**Re: Response to Mangoola Coal Continued Operations Project (SSD-8642)
Request for Additional Information dated 17 February 2020**

Further to your letter dated 17 February 2020, this letter has been prepared on behalf of Mangoola Coal Operations Pty Ltd (Mangoola) to provide a response to the comments made by three NSW government agencies on the Mangoola Coal Continued Operations Project (MCCO Project) Response to Submissions (RTS). A response to the comments noted in your request for further information is provided in **Section 2.0**.

FIGURE 1
Indicative Final Highwall Cross-Section
(Northern Void)

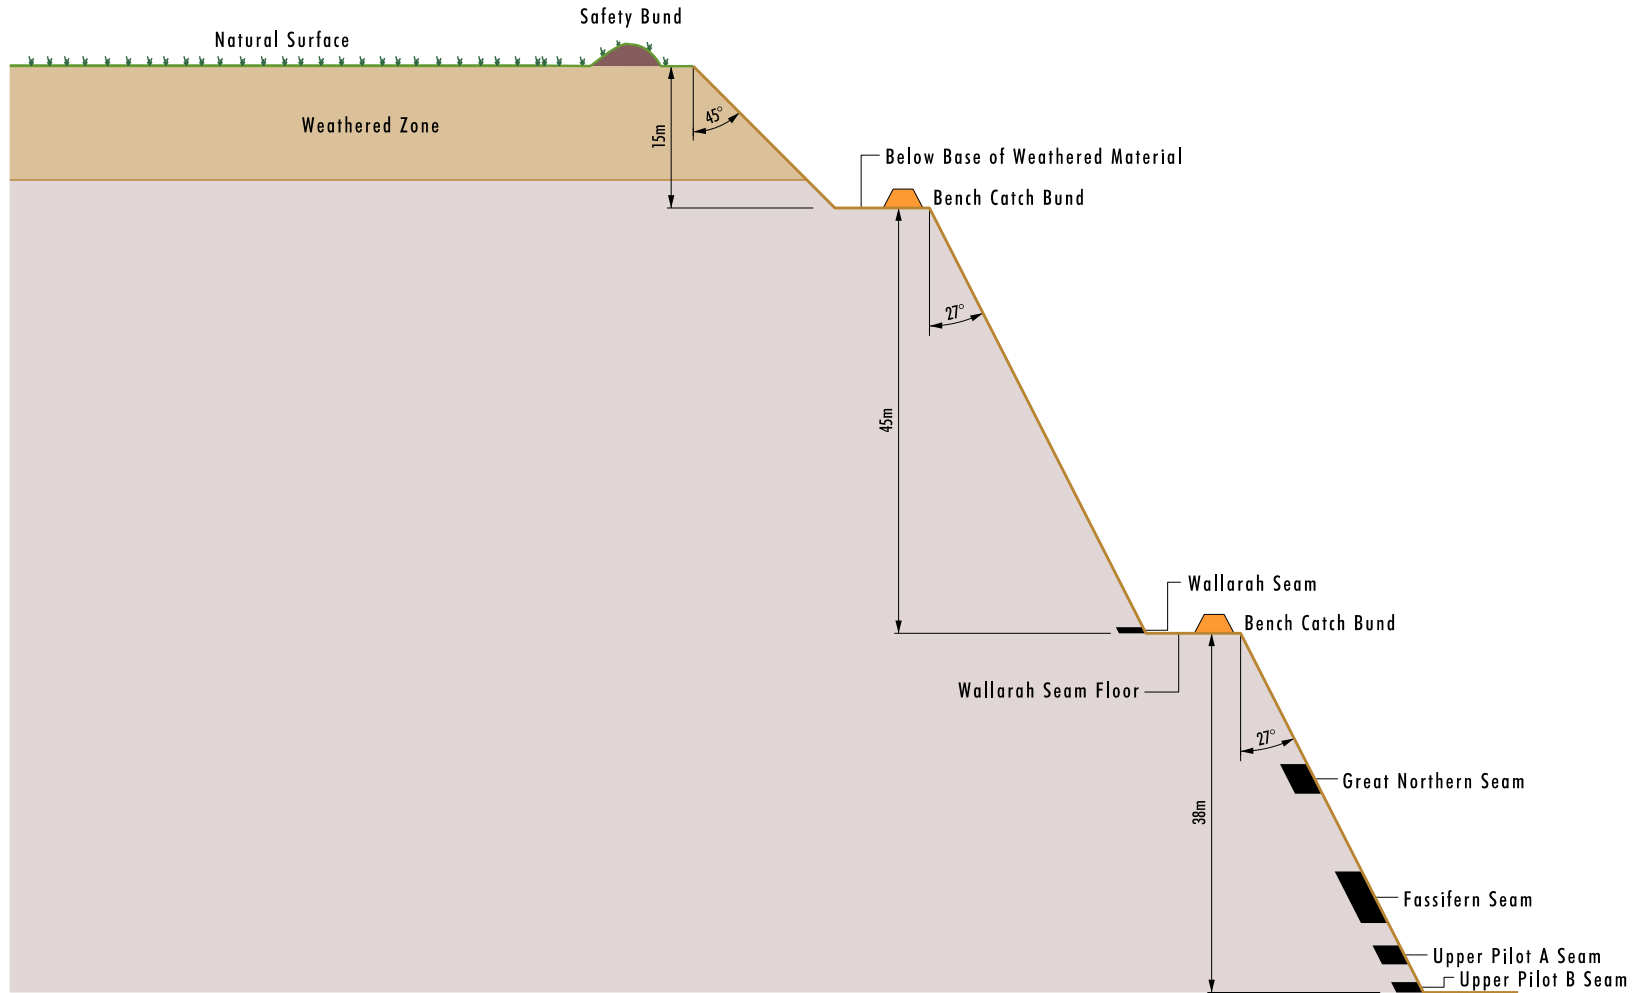
- **It is noted that the Applicant has provided a description of preliminary recommendations provided by the geotechnical assessment such as bench widths and minimum setbacks, however bench height and slope has not been provided.**

- **It is noted that the Applicant has committed to further investigation of alternatives to the use of safety berms along the top of each highwall, however no alternative or control measures to address ongoing maintenance into perpetuity has been presented.**

In the area of the northern void, where the highwall will remain, the indicative maximum total height based on the conceptual mine plan will be in the order of 90 - 100 m. Taking into account the geotechnical advice from Lambert Geotech Pty Ltd, **Table 1** provides an indicative profile for bench heights and slopes for the final landform from the original ground level to the basal (UPA) seam at the depth of mining. This typical profile is indicatively illustrated on **Figure 1**.

The inclusion of a safety berm along the top of the highwall is designed to reduce the potential for inadvertent access. This safety berm, along with the battering back of the upper section of the highwall to a slope angle of 45 degrees (refer to the response to the preceding comment) will mean that there will not be inadvertent access to steep highwall slopes (that is you would need to cross a safety berm and the 45 degree slope of the weathered zone to reach the steeper highwall).

A conceptual indicative design for remaining highwalls and safety berms in the MCCO Project final landform is provided in **Figure 1**.
